APPLICATION NO.	FILING DATE	FIRST NAMED INVENTOR	ATTORNEY DOCKET NO.	CONFIRMATION NO.
10/626,284	07/24/2003	Erdman O. Spradlin	M309	1463

Office Action Summary

This is a first office action for serial number 10/626284, entitled Gutter System with Snap Together Parts, filed on July 24, 2003.

SNAP-ON DECORATIVE GUTTER COVER

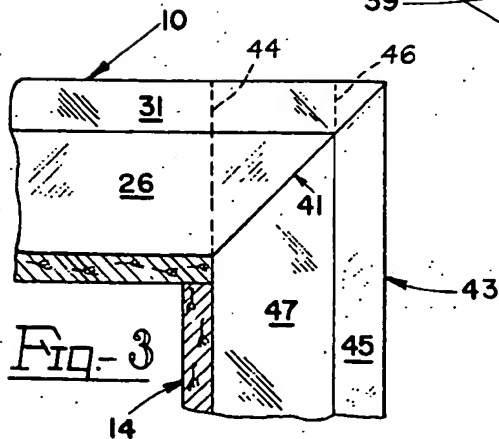
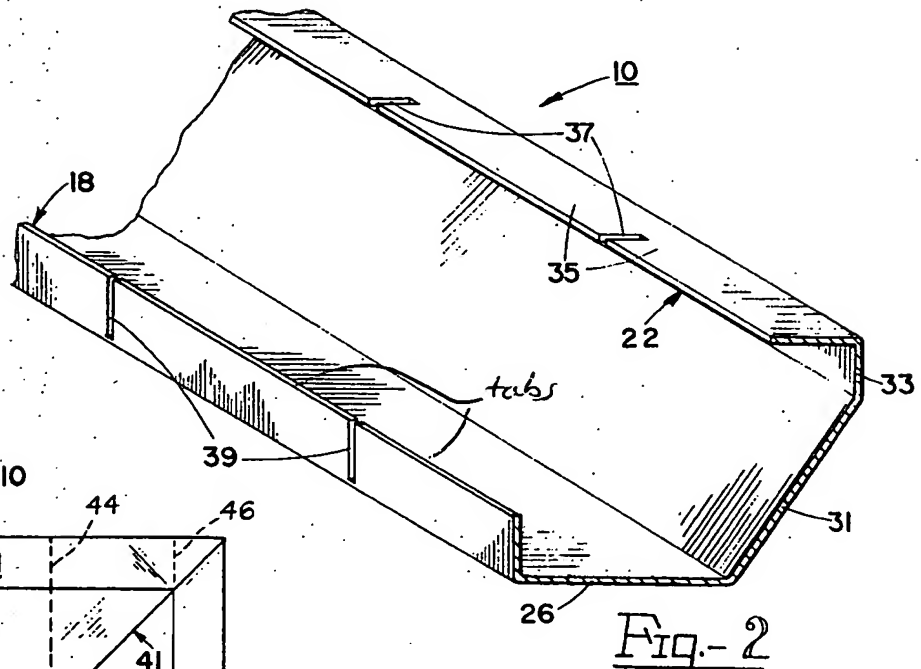
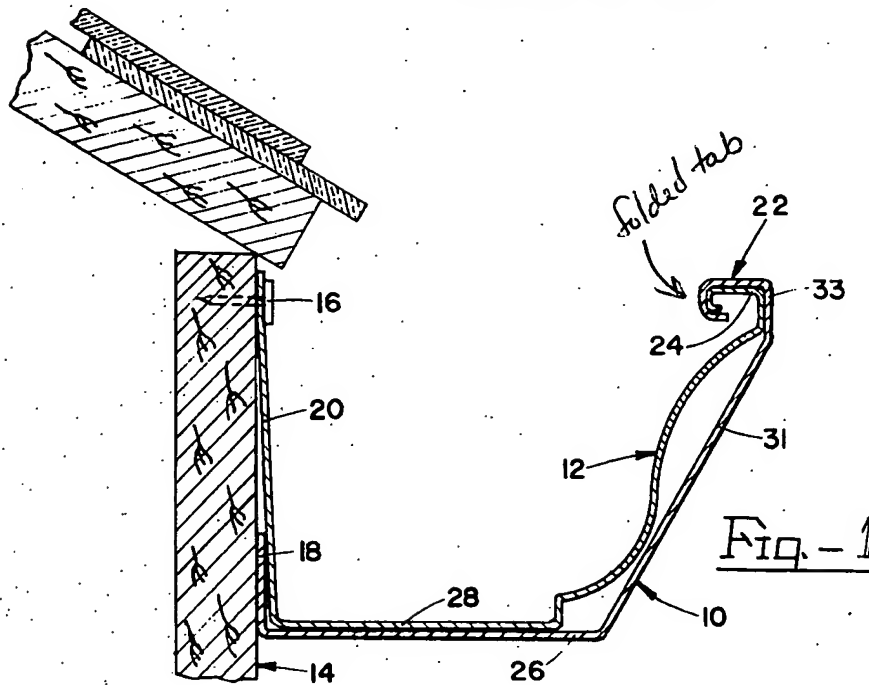
Formanek discloses the claimed invention a length of gutter having a vertical fascia panel, comprising, a lip (22) extending from an upper edge (33) of said outer panel, a plurality of transverse cuts (37) in said lip (22) to form a plurality of adjacent tabs (35), a plurality of transverse cuts (39) in an upper edge of said fascia panel (18) to form a second plurality of tabs (figure 2), and said length of gutter having an end (figure 3) configured for nesting into an end of an adjacent length of gutter (at corner) wherein said tabs on said lip and said tabs on said fascia panel may be folded over to lock nested ends to one another (column 3, lines 16-21); a gutter unit portion (12) comprising an end adapted to nest with respect to said end of said length of gutter (column 3, lines 16-20), and a tab for folding over a portion of said length of gutter for locking said unit gutter portion to said end of said length of gutter (column 3, lines 16-21); a fascia panel

(18) having an upper end (where 18 points to), and a plurality of spaced cuts (39) in said upper end, said spaced cuts forming said tab (attached figure 2); and, a forward panel (33), a lip (22) on said forward panel, a plurality of spaced cuts (39) in said lip (22), said spaced cuts forming said tab (at 35).

Formanek discloses the claimed as stated above in claim 6, including a floor panel (26) and a fascia panel (18), an outer lip (22). Formanek does not disclose an arcuate or curved portion between the floor panel and the fascia panel. It would have been an obvious matter of design choice to provide an arcuate or curved portion between the floor panel and the arcuate portion, since such a modification would have involved a mere change in the shape of a component. A change in shape is generally recognized as being within the level of ordinary skill in the art. Also, the applicant has not disclosed that this curved portion solves any stated problem or is for any particular purpose and it appears that the invention would perform equally well with the portion of the gutter as it is disclosed in the cited art.
